Product Change Notification(PCN)

AWH XXG-0XX2-T Ejector header, PH2.54

Change Notification: PCN 20190128 AWH XXG-0XX2-T

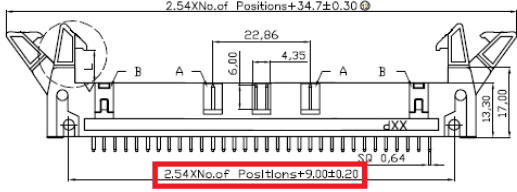
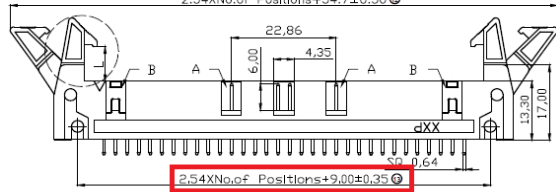
AWH XXG-0XX2-T Old version	AWH XXG-0XX2-T New version
1. The tolerance of fix hole is $\pm 0.20\text{mm}$  2. Dimension L of short latch is 4.50mm  3. the situation with/without slot "A"/"B" as the following  ENVIRONMENTAL ① 1. Operation Temperature: -40°C to $+105^{\circ}\text{C}$ 2. Soldering Temperature: $235^{\circ}\text{C} \pm 5^{\circ}\text{C} / 5\text{s} \pm 1\text{s}$ 3. Packing : Tray 4. No side slot "A" and "B" from 6 to 16 pin No side slot "A" from 18 to 58 pin	1. The tolerance of fix hole is $\pm 0.35\text{mm}$  2. Dimension L of short latch is 4.00mm  3. the situation with/without slot "A"/"B" as the following  ENVIRONMENTAL ① 1. Operation Temperature: -40°C to $+105^{\circ}\text{C}$ 2. Soldering Temperature: $235^{\circ}\text{C} \pm 5^{\circ}\text{C} / 5\text{s} \pm 1\text{s}$ 3. Packing : Tray ④ 4. Without side slot "A" and "B" for 06-18P Without side slot "A" and with slot "B" for 20-58P With slot "A" and "B" for 60-64P

For detail, please take attached new drawing: ASS 2311 C0rev10 for reference
